# **Architectural Review Board Staff Report**

Meeting Date: November 14, 2019

Description: Downtown Chesterfield Category C, Lot B (AC Hotel) SDSP: A Site

Figure 5: Exhibit 1 from Governing Ordinance

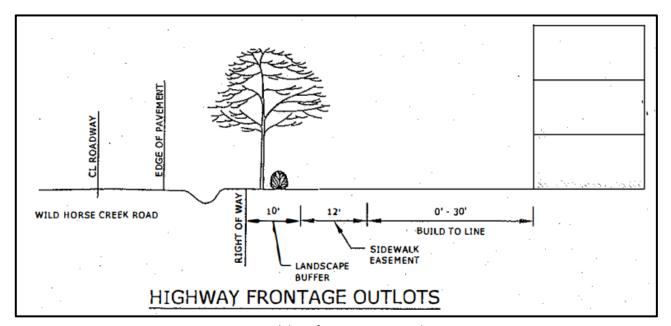
The applicant is seeking a modification from the category standards "Highway Frontage Outlots" set forth in the governing ordinance similar to the approved adjacent Lot A . Figure 5 depicts the streetscape in which the applicant is seeking a modification from.

The applicant has provided a modification request stating the intent of the request is to achieve the goals and objectives of the PC&R district. This site focuses on the center of the proposed development with a plaza, roundabout, public art, sidewalks and park benches. The proposed buildings will surround the plaza and bring a "Downtown" feel to the area and further the intent of the PC&R. The applicant is requesting a modification to essentially build the streetscape off of the internal drive vs. WHCR as depicted on the Exhibit in Figure 5.

Staff acknowledges and is supportive of the center drive aisle dictating an urban "Downtown" streetscape vs. the major arterial of WHCR. Staff encourages the maximum interaction with the street and the building's urban form as dictated in the streetscape identified in the governing ordinance exhibit. As proposed, the parking along the center drive aisle deviates from the required streetscape, but is consistent with the same modification approved for Lot A.
